Re: Rapiscan AIT System Radiation Survey Reporting

R-0646-1 Addendum (Documentation Errors)

Product Name	Secure 1000SP (Single Pose)
Serial Number	S50950008
Radiation Emission Measurement	Radiation Survey Dated: 04/28/2010
RSO Initials	[REDACTED]

1. In Beam Dose Measurement: Survey Table. 1

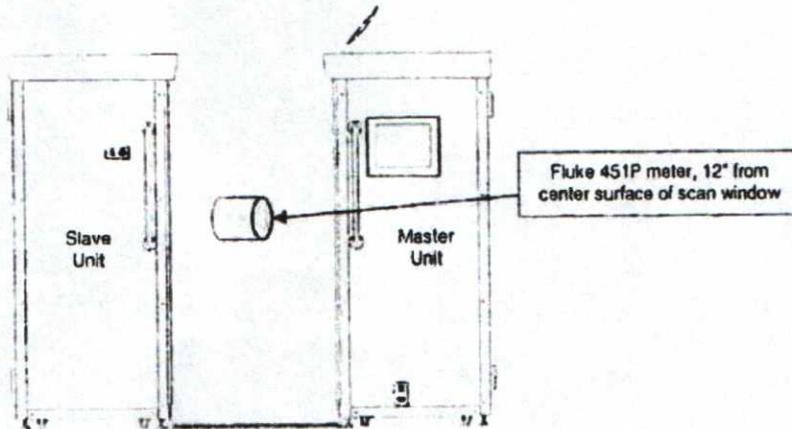
1. No value indicated for background radiation. Typical values range from 7uRem/hr to 13uRem/hr at sea level. Note: Absence of value has no adverse impact on calculations.
2. Technician indicated scan time as 7 seconds. Correct scan time is 3 seconds.
3. TABLE 1: Incorrect presentation of data in Column 3 for Measured Exposure. Indicated values are 36uR and 31uR. Corrected values are 3.6uR and 3.1uR. The values were corrected by technician when calculating Effective Dose.
4. TABLES 2 and 3: Incorrect presentation of data in Column 6 for Dose Equivalent. Indicated values are .18 uRem. The correct value should be 1.8 uRem.

The service technician should attend refresher training.

The corrected data indicates this system was operating within expected parameters. No re-survey is required for this system.
